TechnologyOne ECM Document Summary

To: annemarie.townsley@jea.co.nz Ref: 24095
Cc:
From: simon.bloomberg@e3scientific.co.nz
Date: 18 July 2024
Subject: Re: RM240352 – Request for review of water quality improvements
for a subdivision under Policy 24.2.4.2 of the QLDC District Plan

From: "Annemarie Townsley" <annemarie.townsley@jea.co.nz>
Sent: Thu, 8 Aug 2024 15:55:43 +1200
To: "Resource Consent" <resourceconsent@qldc.govt.nz>
Cc: "Courtney Briggs" <Courtney.Briggs@qldc.govt.nz>; "Ron Macrae" <ron@cmp.net.nz>
Subject: RM240352 - Macrae - Response to Further Information Request - email 1 of 2
Attachments: Attachment A - Email from Central Pump Services.png, Attachment B - Water Quality Test Results.pdf, Attachment C - Email from Don Moir re ww design.pdf, Attachment D - Water tank locations.pdf, Attachment E - Rockfall Bund Location.pdf, Attachment F - Updated floor areas plan.pdf, Attachment H - e3 memo re water quality.pdf, Further Information Reply 8.8.24.pdf

From: "Annemarie Townsley" <annemarie.townsley@jea.co.nz>
Sent: Thu, 8 Aug 2024 15:56:56 +1200
To: "Resource Consent" <resourceconsent@qldc.govt.nz>
Cc: "Courtney Briggs" <Courtney.Briggs@qldc.govt.nz>
Subject: RM240352 -

Water tank locations

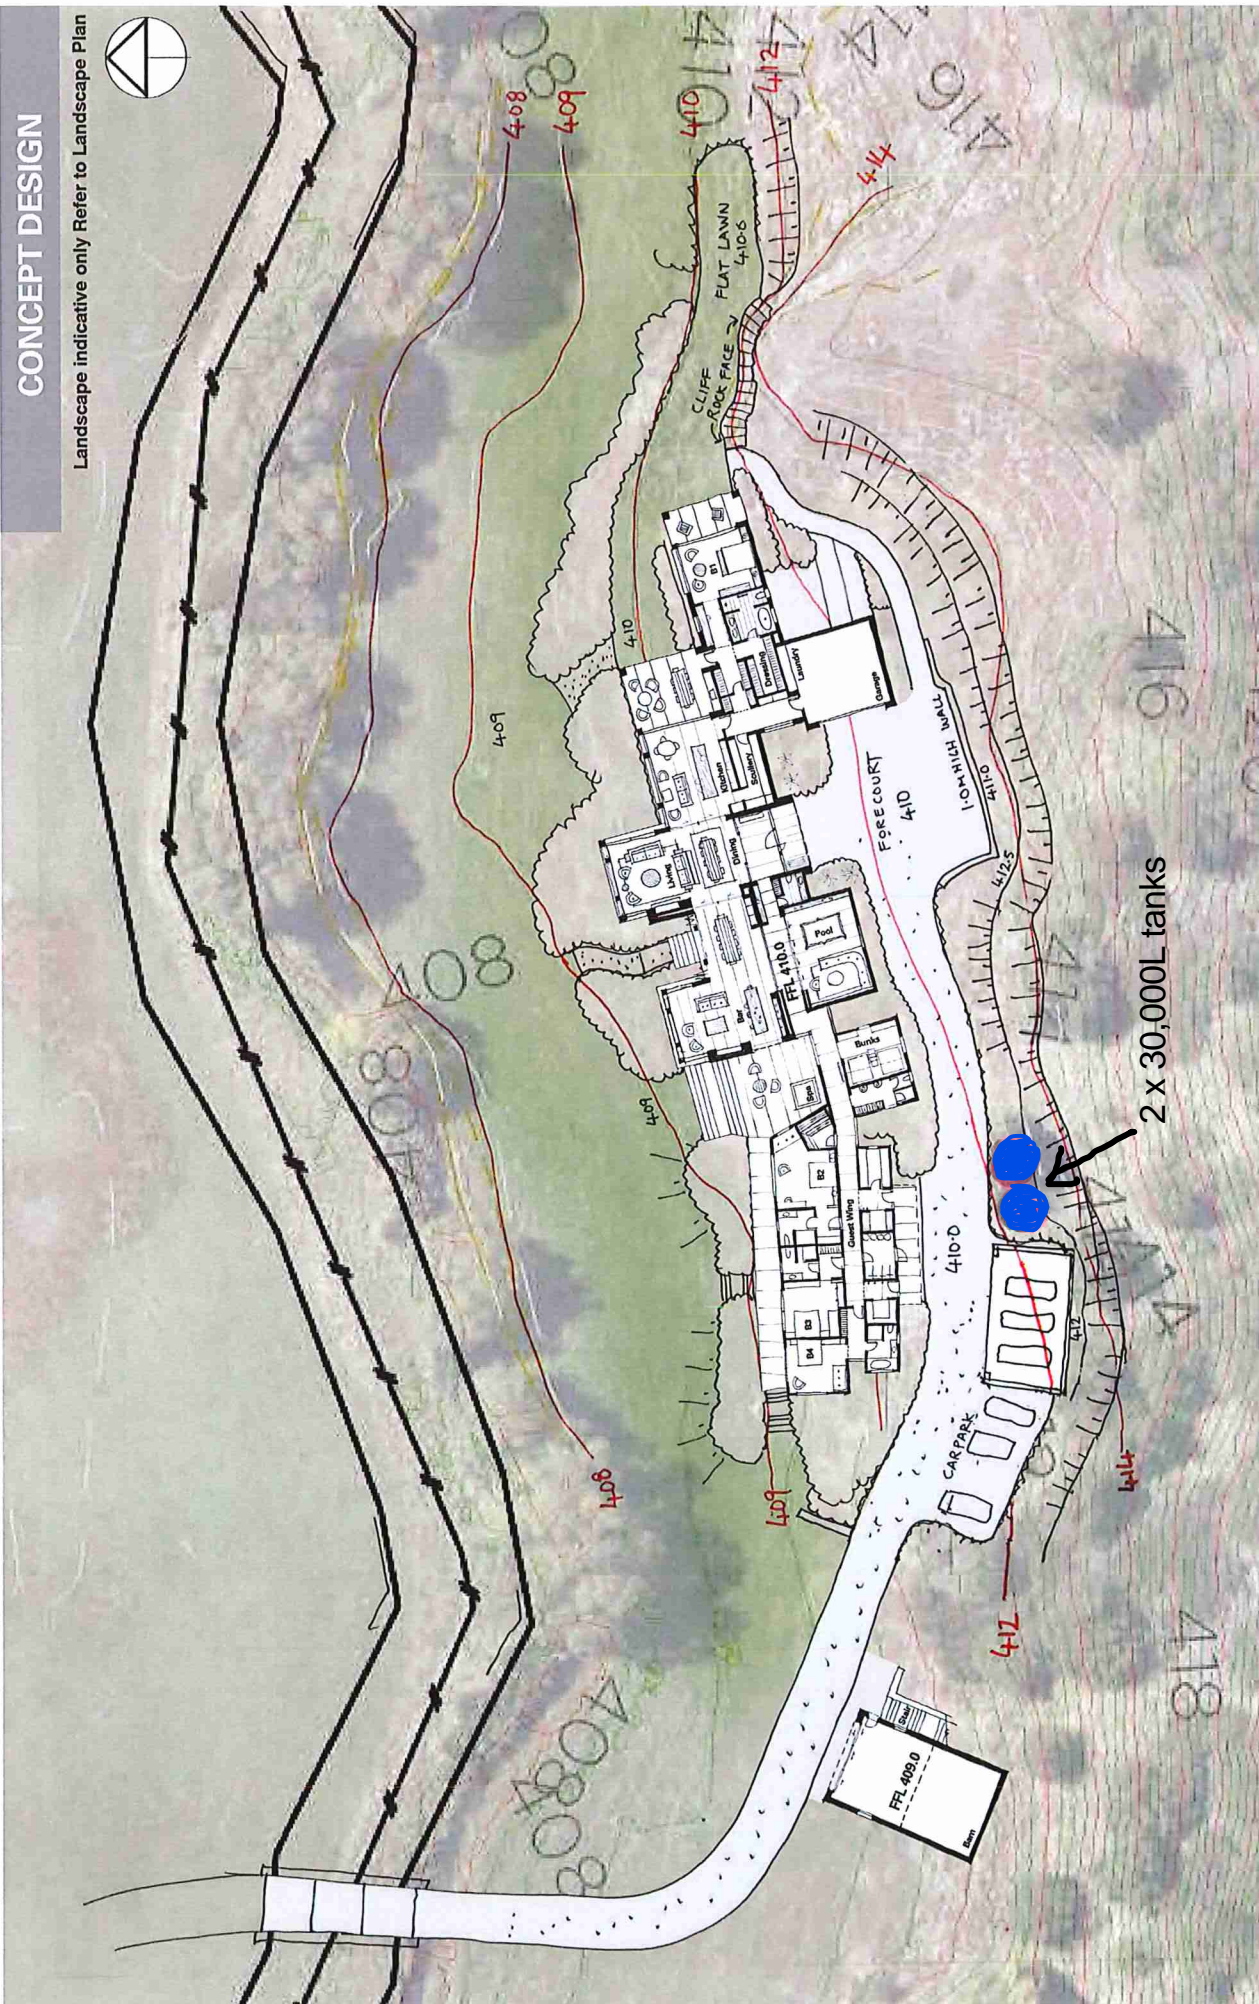
8. *Please confirm with suitable evidence demonstrating that the firefighting provisions associated with the existing and proposed building platforms can meet the current firefighting standards. Please show the proposed locations of the firefighting tanks on the site plans.*

Two 30,000 litre water tanks will be located at the rear of the dwelling, at the base of the bank on the eastern side of the garage, adjacent to the driveway. See attached marked-up site plan (**Attachment D**). This will meet the following requirements set out in Rule 25.4.19:

- water storage of at least 45,000 litres with an outlet connection point that can provide 1500L/min (25 L/s) and any necessary couplings;
- a hardstand area with a minimum width of 4.5m and length of 11m located within 6m of the firefighting water supply connection point and capable of supporting a 20 tonne fire service vehicle;
- a connection point for the firefighting water supply located more than 6m and less than 90m from the residential building; and
- access from the property road boundary to the hardstand area capable of accommodating a 20 tonne fire service vehicle.

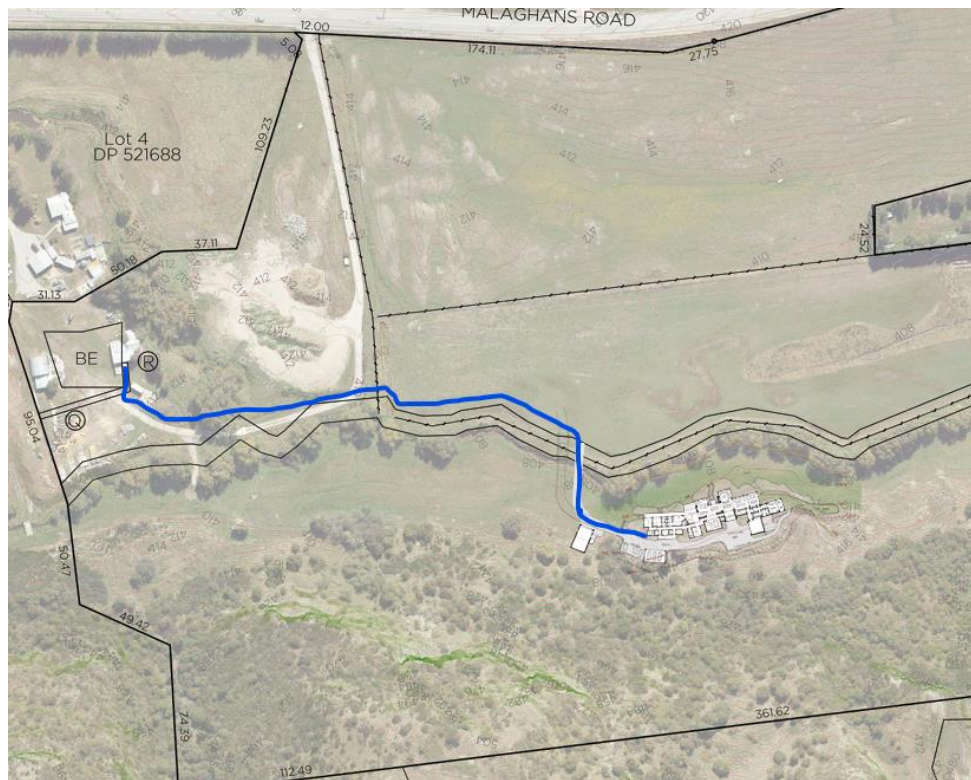
5. *Please provide the water supply bore logs and latest test results to confirm that the existing water source servicing the subdivision is of sufficient capacity to service one additional allotment with a minimum of 2,100L day in terms of quantity and quality.*

6. *Please show the indicative location of water supply reticulation from the source to the location of the proposed building platform, if the water supply pipe is fastened to the bridge similar to the wastewater pipe, please provide some additional information on frost protection measures that will be adopted.*

The water supply pipe from the existing bore to the building platform will be in the approximate location marked up on the plan above. The pipe will be attached to the bridge across Mill Creek. It will be lagged to prevent freezing.
